# Access Compliance Report

## Public Rights-of-Way

Intersection ID: 24411	Main Street: CAMAROSS_DR	Cross Street: ELPHIN_CT	Location:	E
ADA ID: 54625A05E04F	Ramp Type: Perp	Initial Pass/Fail: Fail	Overall Compliance: No	Severity Score: 12.5

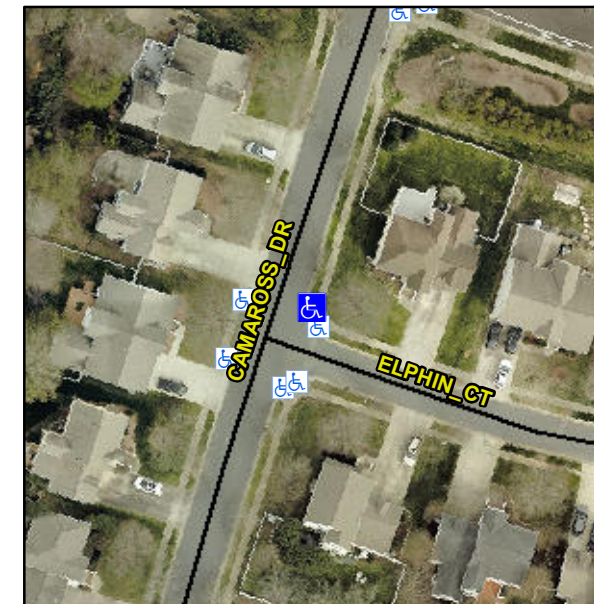
**R304.2.2**

Compliance	Description	Data	Compliance	Description	Data
N/A	Ramp Length (in)	48.0	No	Ramp Slope (%)	8.9
Yes	Ramp Width (in)	48.0	Yes	Ramp XSlope (%)	0.2
N/A	Flare Type LT	N/A	N/A	Flare Type RT	N/A
N/A	Flare Slope LT (%)	N/A	N/A	Flare Slope RT (%)	N/A
N/A	Flare Traversable LT?	N/A	N/A	Flare Traversable RT?	N/A
N/A	Landing Length (in)	N/A	N/A	DWS Provided?	N/A
N/A	Landing Width (in)	N/A	N/A	DWS Contrast?	N/A
N/A	Landing Slope (%)	N/A	N/A	DWS Length (in)	N/A
N/A	Landing X Slope (%)	N/A	N/A	DWS Full Width?	N/A
N/A	Landing Curb? (Y/N)	N/A	N/A	DWS Offset (in)	N/A
N/A	Shared Landing?	N/A			
N/A	Gutter Ponding?	N/A	N/A	Gutter Slope (%)	N/A
N/A	Gutter Lip Ht (in)	N/A	N/A	Gutter X Slope (%)	N/A
N/A	Painted X Walk1?	No	N/A	Painted X Walk2?	N/A
	X Walk 1 Direction	To NW		X Walk 2 Direction	N/A
N/A	X Walk 1 Width (in)	N/A	N/A	X Walk 2 Width (in)	N/A
	X Walk 1 Slope (%)	3.9		X Walk 2 Slope (%)	N/A
	X Walk 1 X Slope (%)	2.2		X Walk 2 X Slope (%)	N/A

**Remove & Replace Entire Ramp.**
